**TR 8 Adequacy Response 11-2-2020 - Cross Gold Mine M-1977-410**

RE: Cross Gold Mine, Permit No. M-1977-410, Technical Revision No. 8 (TR-08), Preliminary Adequacy Review

Cross Mine Technical Revision No. 8

Map 1

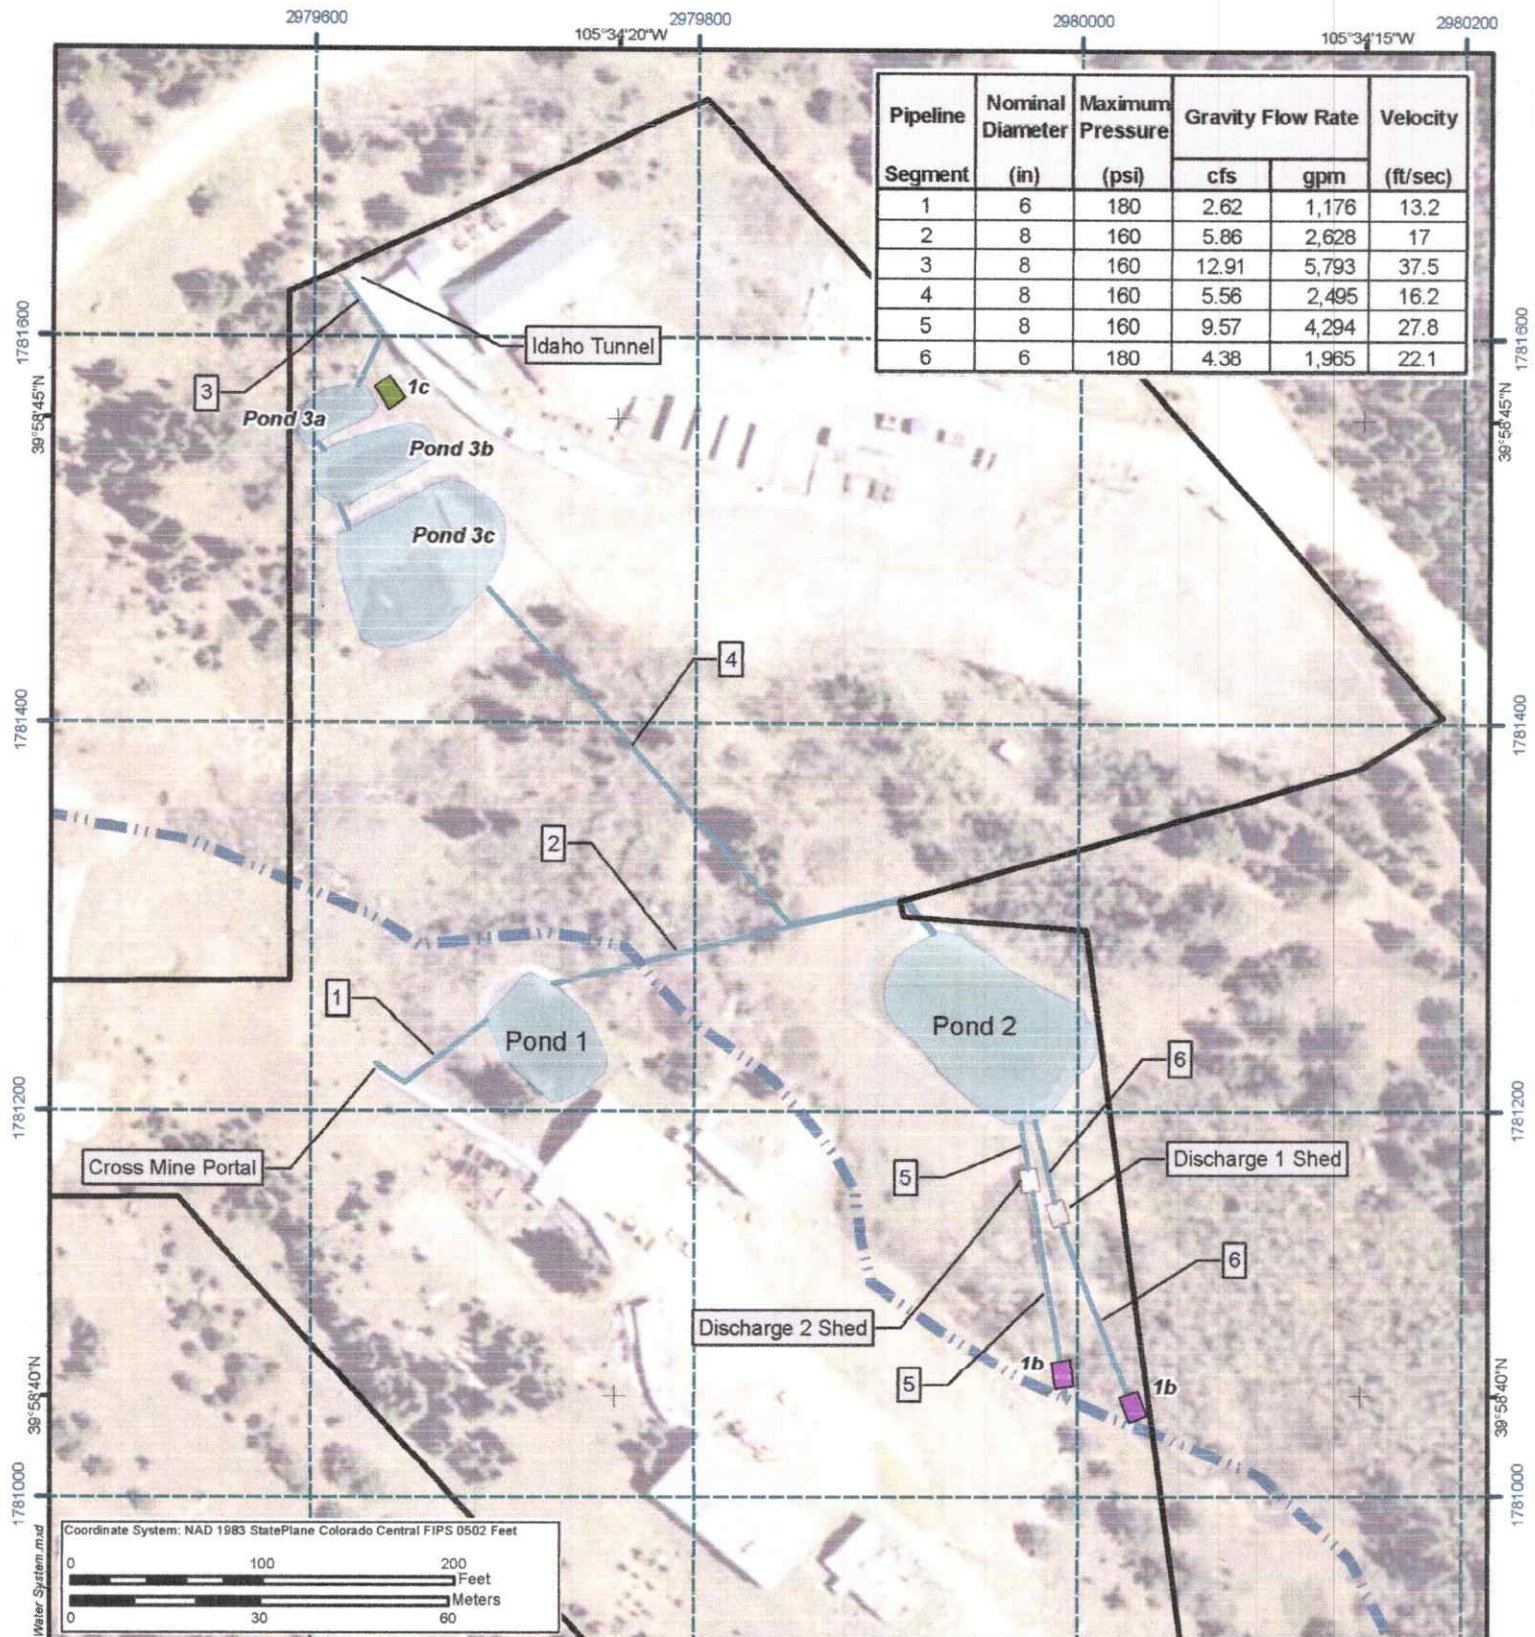
- 1) *On Figure 1 – Water Management System, please address the following:*
  - a. *Please identify the approved Permit Boundary as such and not as “SWMP boundary”.*
  - b. *Please identify the location of the discharge point on Coon Track Creek that is monitored under the NPDES permit.*
  - c. *Please identify the location of the proposed lime feed and control building.*
  - d. *Please clarify if Pond 3C is shown at its current dimensions or at its proposed expanded dimensions.*

For items a, b and c, please see the revised Water Management System map (Water Management System Map 1).  
d. The new pond 3C fits inside the old pond original footprint, however the banks of the pond have been dug out significantly to allow for more volume.

**Map 3**

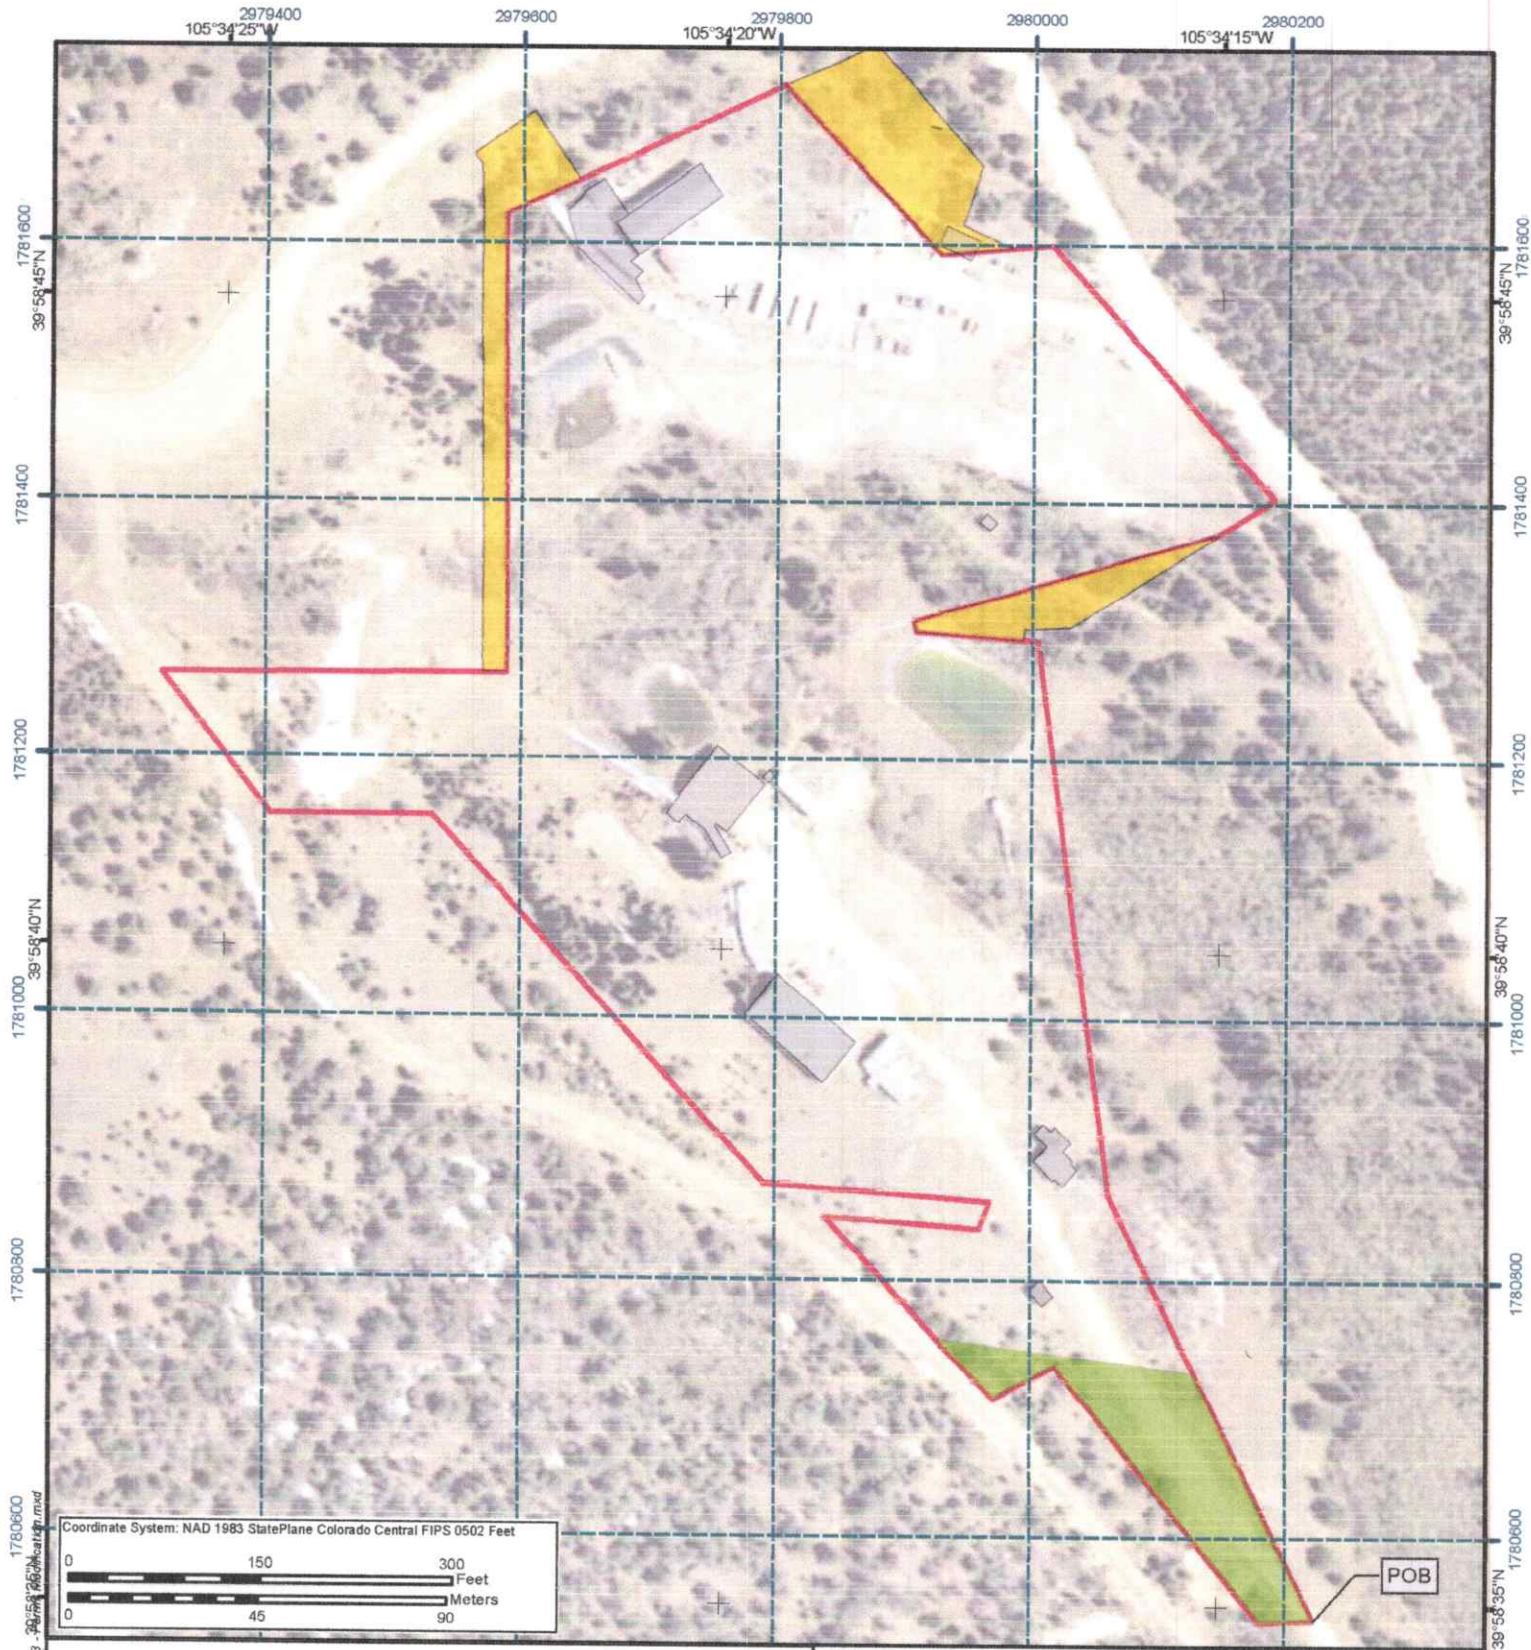
- 2) *Figure 1 – Water Management System shows Ponds 3A-C, especially Pond 3A, to be located very close to the approved permit boundary in that area. Does the operator believe there is enough room present around these ponds to complete the rehabilitation project proposed in this revision? Please be advised, any disturbance that occurs outside of the approved permit boundary would be considered offsite damage for which enforcement actions may be pursued. If additional space is required, the permit area must be expanded through the Amendment process.*

GIR believes pond 3A to be very close to the existing permit boundary. As was discussed with DRMS on 9/15/2020, the permit boundary will be amended twice in the coming months. First, GIR is to submit a 'Partial Release of Permit Area' which will reduce the overall permit boundary by 0.40 acres (DRMS Request for Partial Release of Permit Area Map2). Through the upcoming Amendment #2 process, the Disturbance area will then be increased to include additional land to the South West side of Pond 3A, ensuring all ponds are within the permitted area (Proposed Permit Boundary Modifications Map 3).
